SECTION 00 91 10

ADDENDUM NUMBER 1

- 1.01 DATE: MAY 14, 2018**
- 1.02 PROJECT: AUSTIN HIGH SCHOOL CAREER TECH CENTER**
- 1.03 PROJECT NUMBER: B. C. NO. 2018112**
- 1.04 OWNER: DECATUR CITY SCHOOLS**
- 1.05 ARCHITECT: NOLA | VAN PEURSEM ARCHITECTS, PC**

M-1.2
OF
8

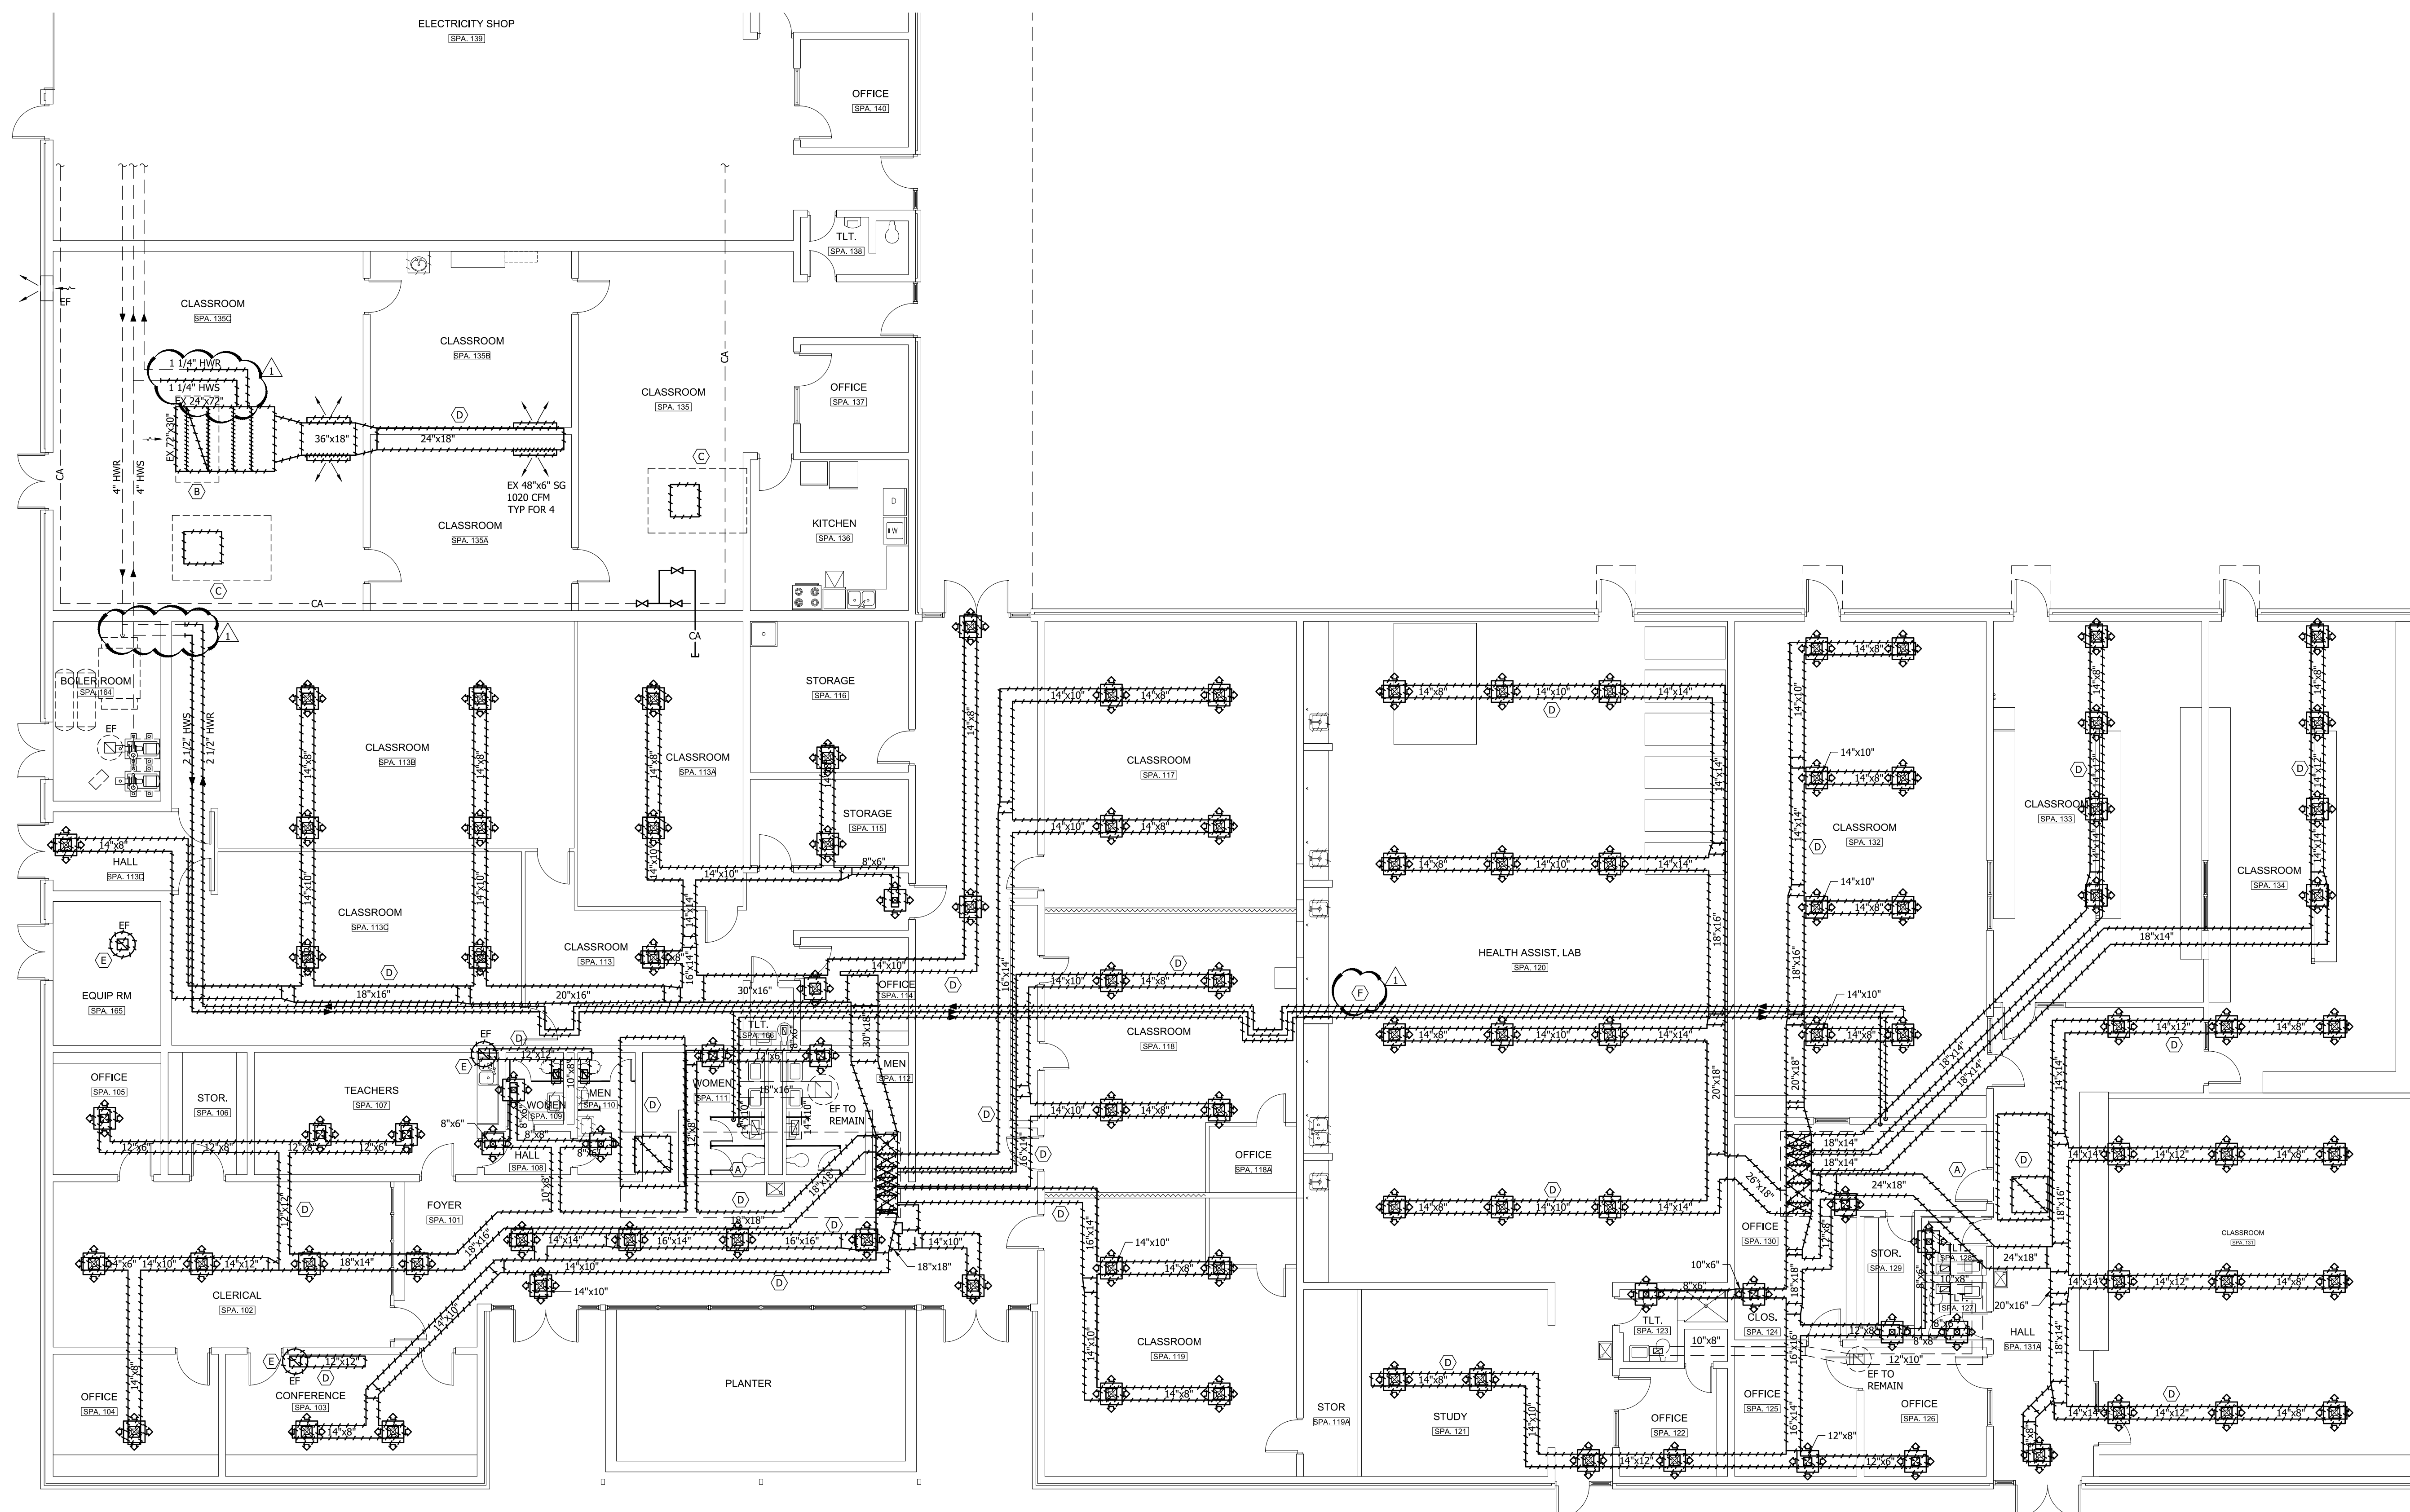
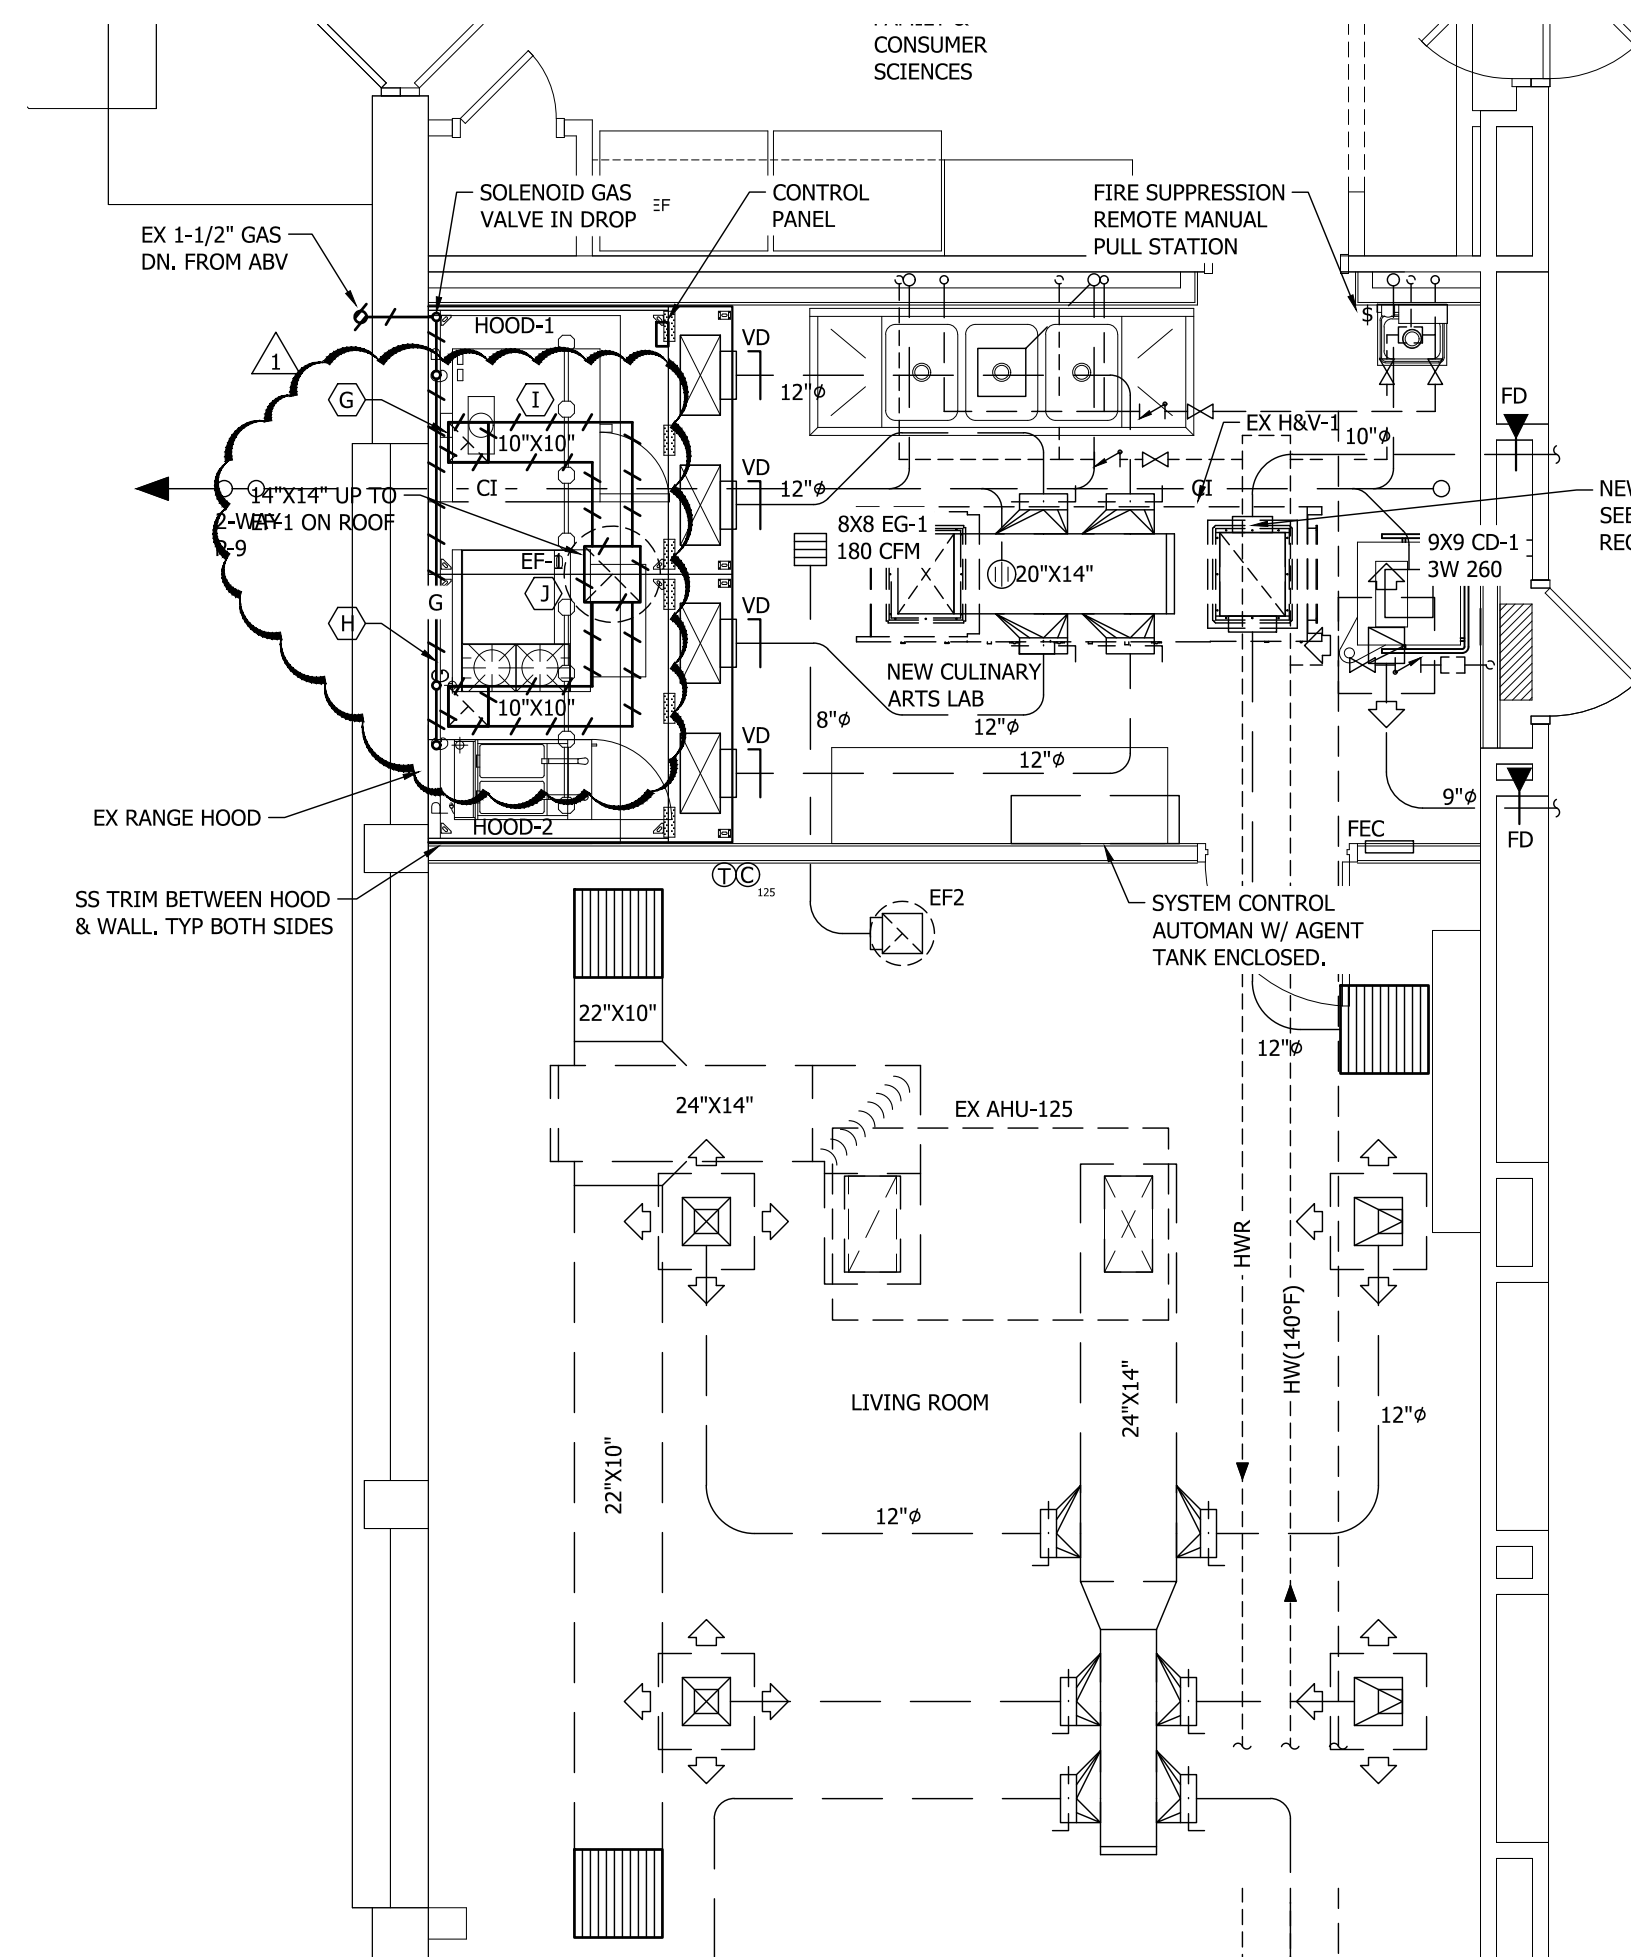
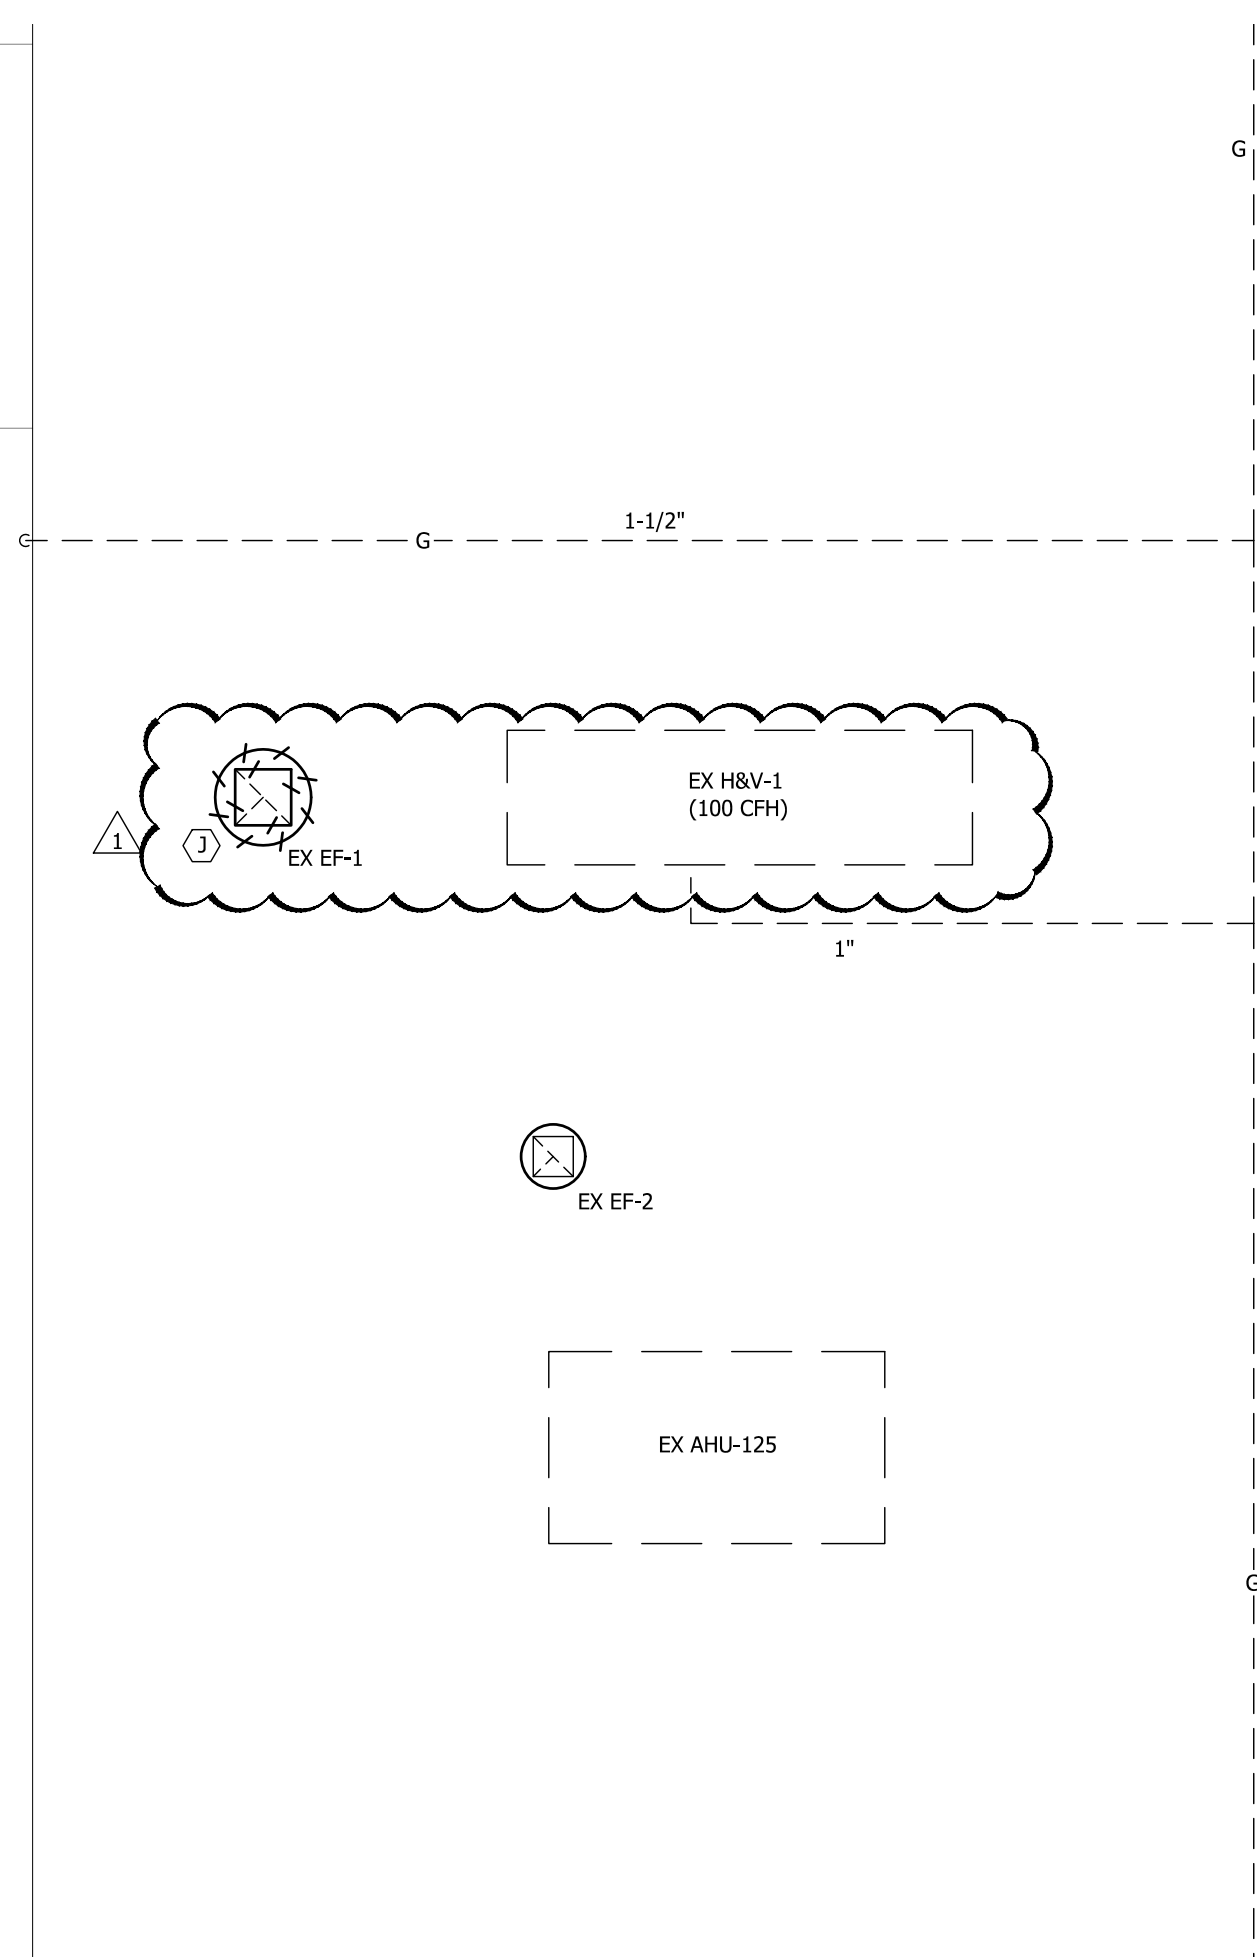
4.14 SHEET M-1.2 - MECHANICAL DEMOLITION FLOOR PLANS:

- A. Replace this sheet in its entirety, the list of changes are as follows:
1. Decatur HS Culinary plans have changed. Scale has been increased and the Key Note items have been identified on the plans.
 2. The roof plan has been changed to show the existing H & V unit to remain and Key Note "J" shown.
 3. Key Note "F" has been identified on the floor plan.
 4. Hydronic hot water piping exiting the boiler room and at the removed H & V Unit Key Noted "B" has added piping shown to be removed as necessary for the installation of the new bypass assemblies shown on the Mechanical Floor Plans.
 5. Key plans have been re-labeled, re-positioned and the area of the work highlighted.
 6. North arrows have been corrected to depict true north on the plans.
